ADDENDUM NO. 1 TO PLANS AND SPECIFICATIONS

Project: Orange Grove Vol. Fire Station # 2 Bldg. Addition (6801 Rocky Ridge Road)
Date: Friday, March 6, 2026
By: Jorge Rodriguez, AIA 
Bid Date: March 12, 2026
Bid Time: 2:00 P.M. EST
Bid Location: Orange Grove Fire Station # 1 (6800 Orange Grove Road, Hillsborough, NC 27278)

SHEET NO. E4

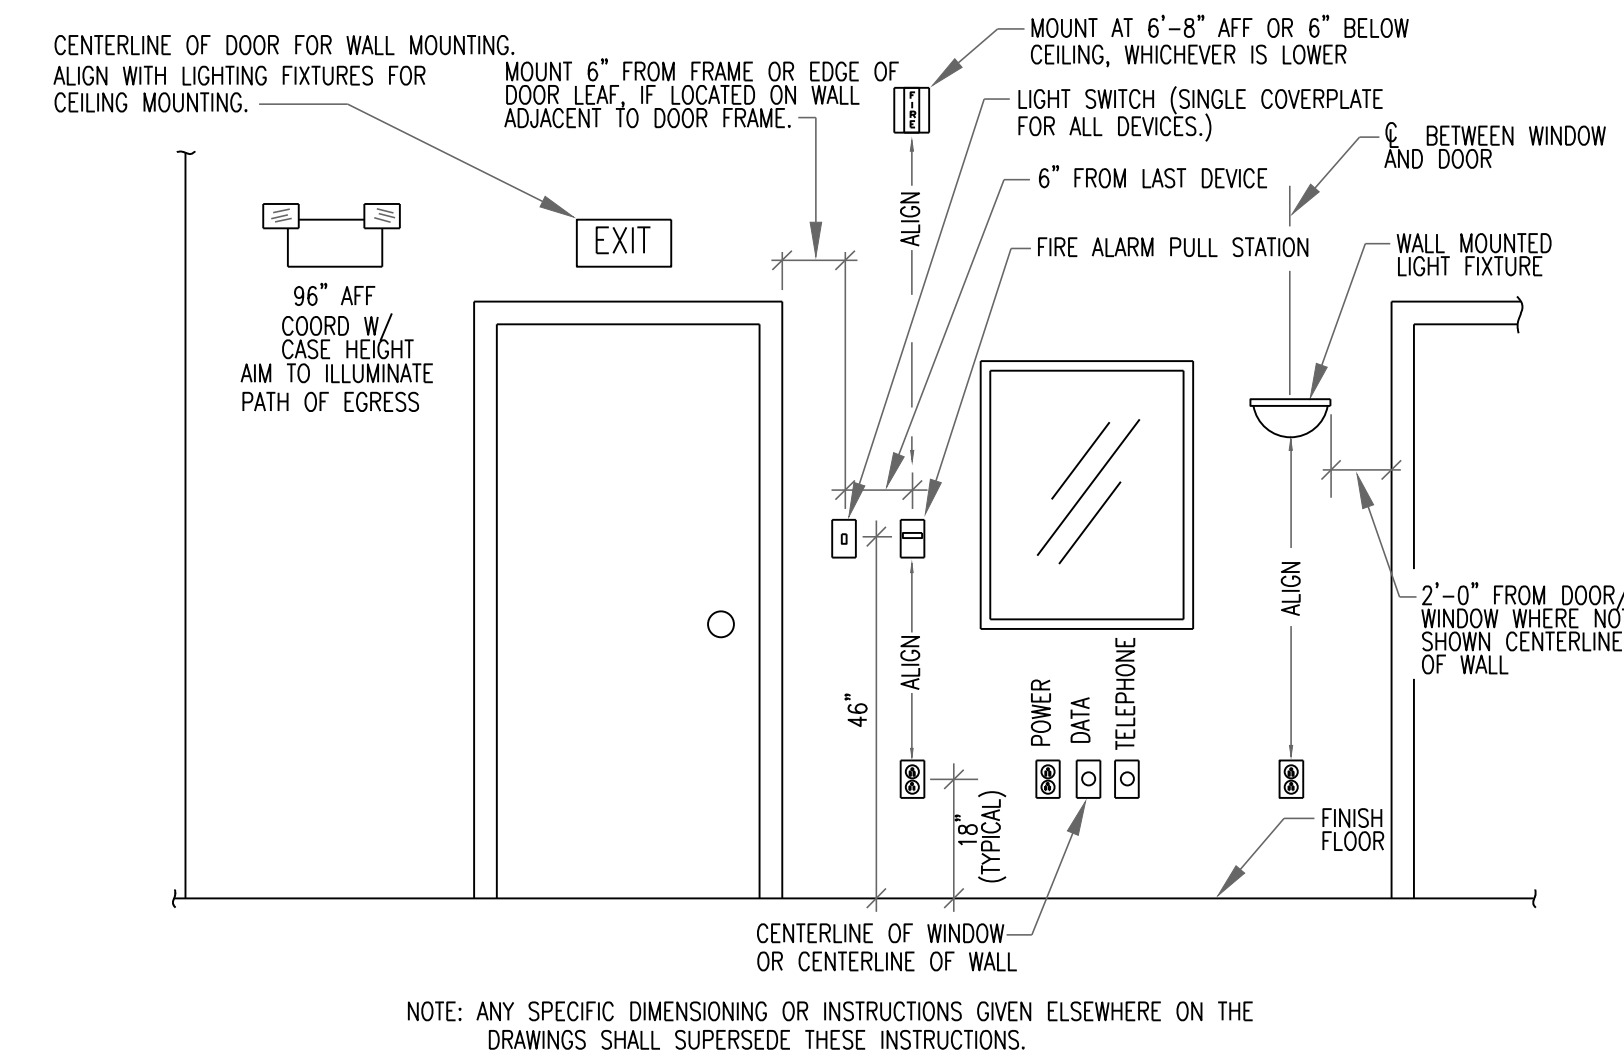
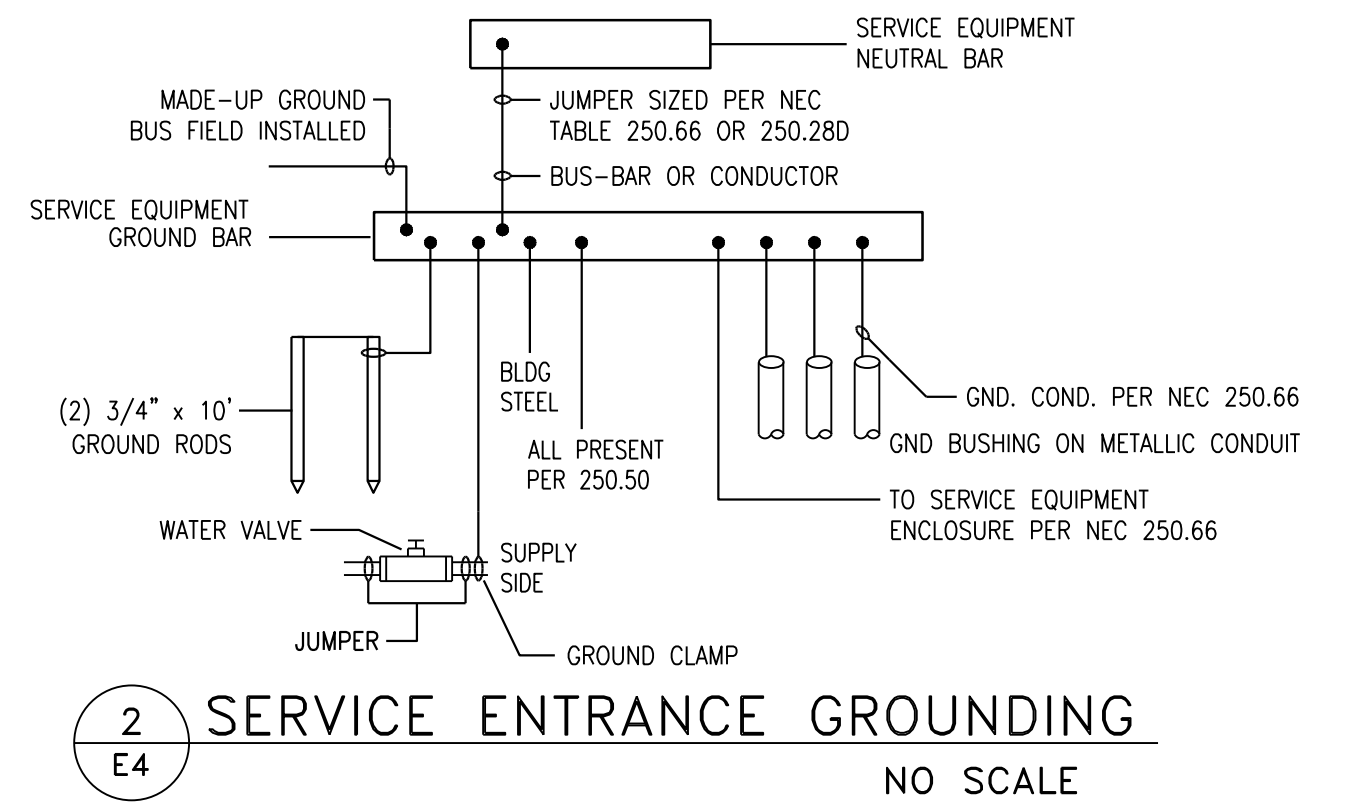
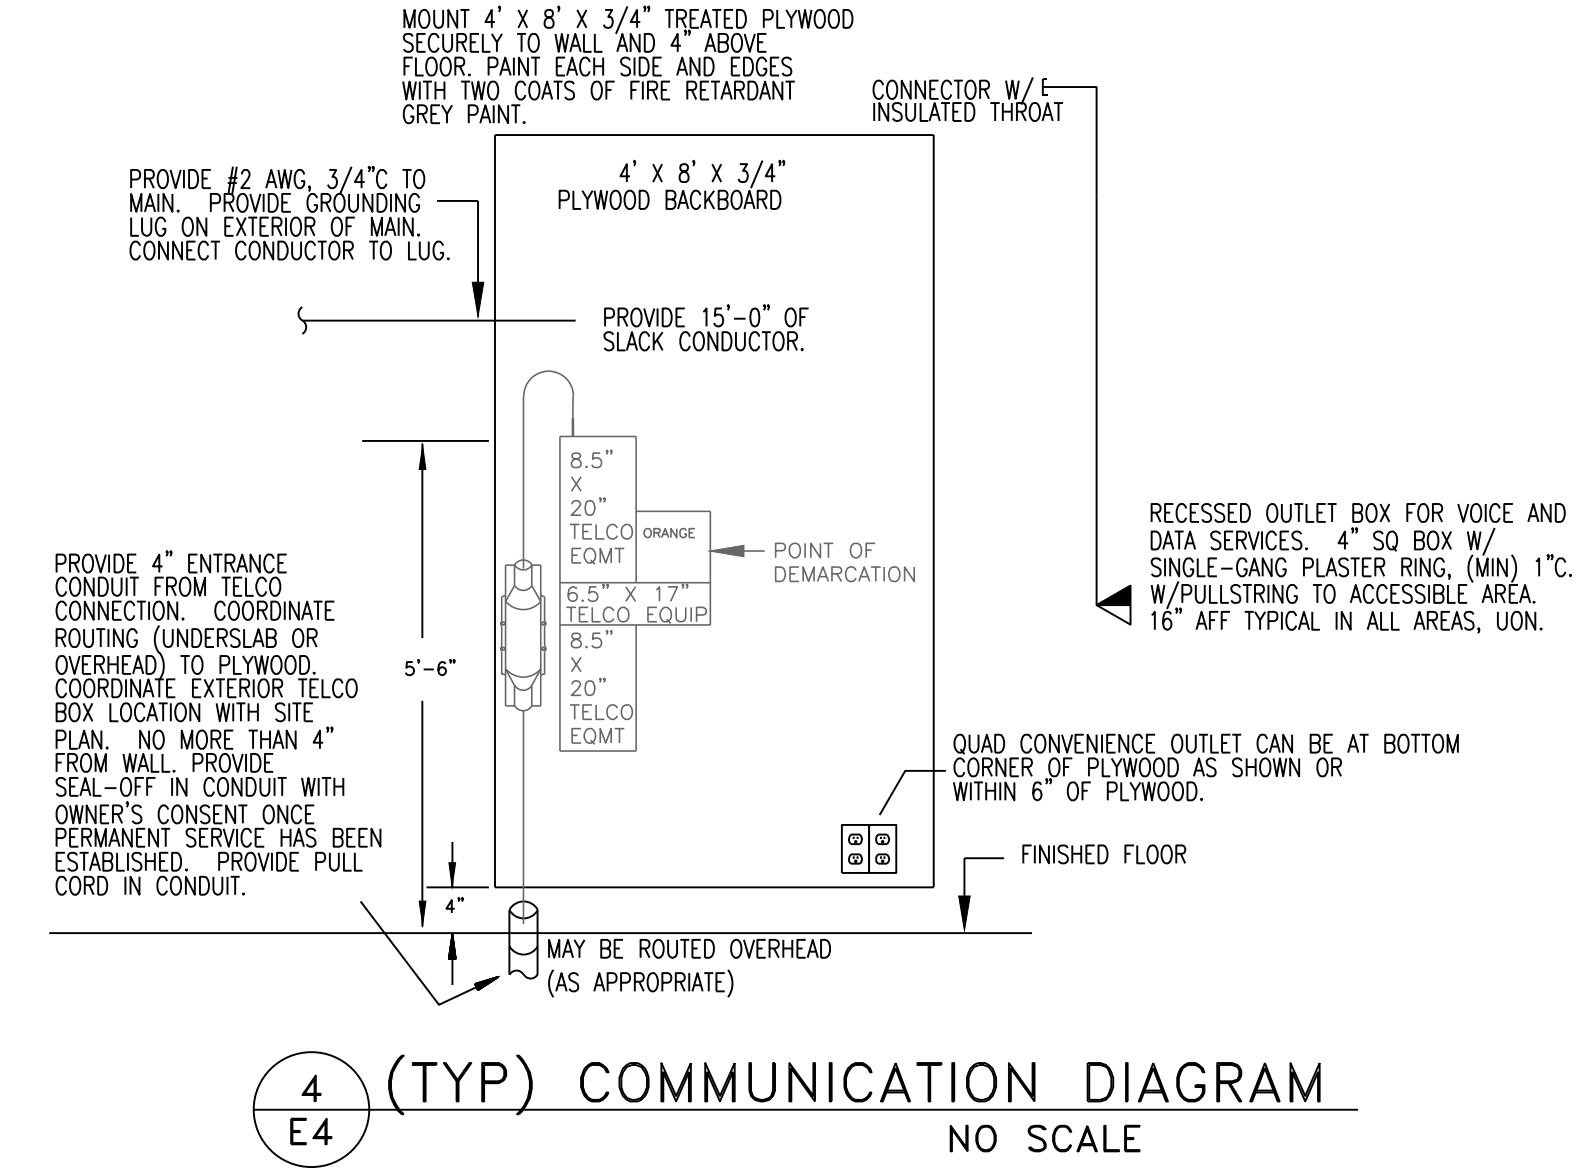
- 4. Sheet E-4:**
 - a. See Booster Pump on Panel A2.
